TECH NOTE

5PK MICRO-V® AT BELT CHANGE ON RENAULT ENGINES

BULLETIN: TSB013_AU

Fig. 1

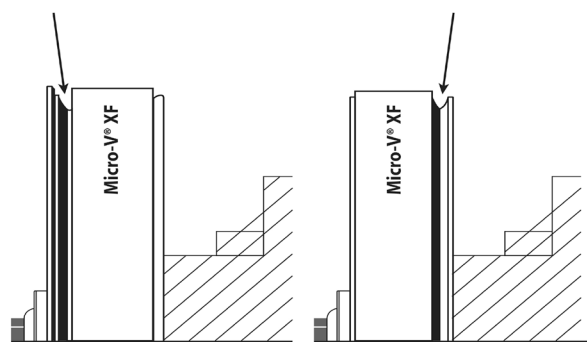
As these 5PK belts run in the initially installed 6 groove pulleys, it is important to install the belt in the correct pulley grooves. This is because there have been cases where incorrect belt placement caused the multi ribbed belt to be destroyed, resulting in parts entering into the timing belt drives and causing considerable damage to the engine.

- Without air conditioning:
 - Power steering pump is belt driven: belt has to be on the inside of the pulleys (fig. 1)
 - Power steering pump is electrically driven (not included in the belt drive): belt has to be on the outside of the pulleys (fig. 2)
- With air conditioning:
 - Belt has to be on the outside of the pulleys (fig. 2)

- Belt has to be on the outside of the pulleys (fig. 2)
